Subject: Airbrake torque tube in the fuselage, airbrakes in the wings

Effectivity: All types and serial numbers: DG-100, DG-200, DG-400

Inspection and reinforcement of the airbrake torque tube (DG-100, DG-200, DG-400)

Inspection and repair of the airbrakes (DG-100, DG-200, DG-400)

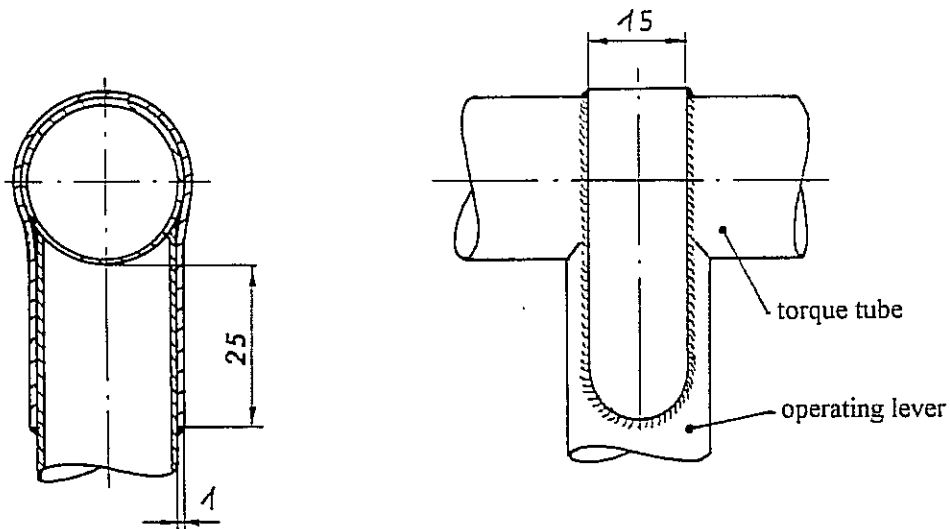
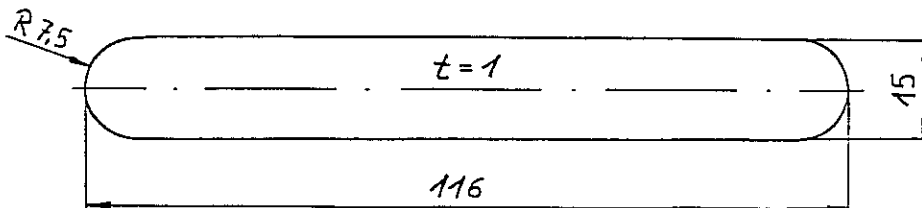
Prior to the next flight the airbrake torque tube in the fuselage must be inspected. Check the welded joint to the operating lever on cracks or deformation when locking and unlocking the airbrakes on the rigged airplane. The airbrake torque tube can be reached through the inspection hole in the fuselage. For inspection of the welding joint use a mirror and a magnifying glass (magnification min. 5x). In case of doubt remove torque tube for closer inspection.

If there are no defects flying operation can be continued until next inspection. If there is even a minor damage suspected instructions 3 must be accomplished prior to next flight.

If necessary the welded joint of torque tube and operating lever must be reinforced by welding an additional steel sheet 1-St-12/2 made of material 1.7734.4 (s. sketch). Visible cracks or other defects of the original joint must be repaired first. All welding must be done with the TIG-welding system (tungsten inert gas) using welding wire 1.7734.2. Where welding is to be done cadmium plating or painting must be removed first by sandblasting.

If the torque tube is damaged by deep cracks and due to this corrosion inside the torque tube or the lever is suspected, the complete part 1St12 must be exchanged.

After welding all metal surfaces must be protected against corrosion. This can be done by painting with suitable primer and paint.

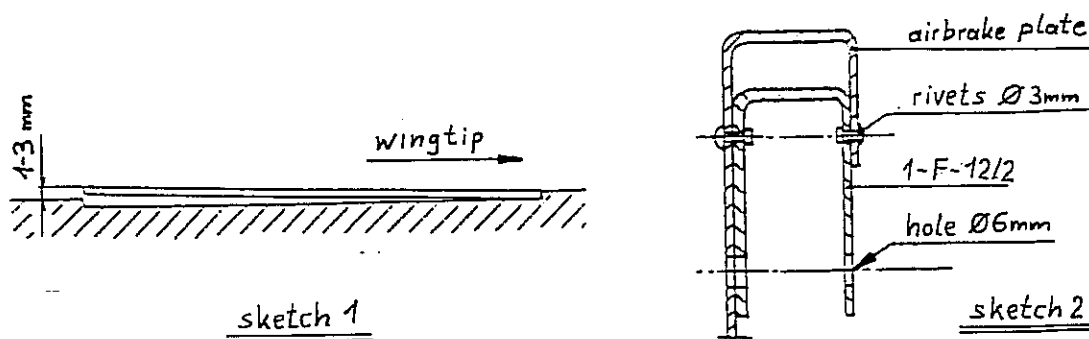
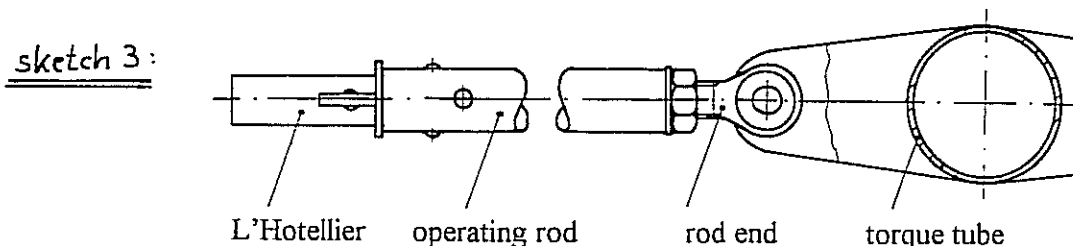
The airbrakes must retract at their outboard end first. When the airbrake cap is flush with the wing surface at the outboard end, the inboard end must be 1-3mm (0.039-0.118in) above the wing surface (s. sketch 1).

If not, modify as follows. With the modification a value of 1-3mm shall be adjusted.

1. Remove the bolt fixing the airbrake plate to the outboard bellcrank.
2. Drill out the 4 rivets which fasten the U-bracket 1F12/2 to the airbrake plate and remove bracket (s. sketch 2). Use a $\text{Ø}3\text{mm}$ (0.118 in) drill.

3. Enlarge the $\text{Ø}6\text{mm}$ hole at which the outboard bellcrank was screwed to the airbrake plate to $\text{Ø}7\text{mm}$ (0.276in).
4. Insert a new bracket 1F12/2 into the airbrake plate and screw it together with the airbrake plate and the bellcrank. Press bracket and bellcrank outboard when tightening the screw.

5. Retract the airbrake and measure the distance of the inboard edge of the airbrake cap to the wing surface. If the desired value of 1-3mm is not reached, you must repeat items 3 and 4. Enlarge the hole in steps from $\text{Ø}7\text{mm}$ to max. $\text{Ø}8\text{mm}$ (0.314in).

6. Drill rivet holes $\text{Ø}3\text{mm}$ (0.118in) through the existing holes in the airbrake plate into new bracket 1F12/2. Fasten 1F12/2 with 4 aluminium poprivets type Fero $\text{Ø}3 \times 6.5\text{mm}$ ALMg5 with steel pin to the airbrake plate.

7. Screw together airbrake plate and outboard bellcrank using new self locking nuts M6 DIN 985-8 zn.
8. Now finally check if the airbrakes retract simultaneously. To measure retract the airbrakes so far, that the first cap is flush with the wing surface at the outboard end. Hold the airbrake handle in this position and measure how high the outboard end of the other airbrake is above the wing surface. Allowance 2mm (0.078in).

9. Also check handle forces to unlock the airbrakes (min.15daN, max.20daN resp. min.33lbs, max.44lbs). If handle force is below allowance elongate the operating rod of the airbrake retracting last by adjusting the rod end (s. sketch 3 below). If handle force is above allowance shorten the operating rod of the airbrake retracting first by adjusting the rod end. When adjustment of the airbrakes is finished don't forget to safety rod ends again by tightening the counter nut.
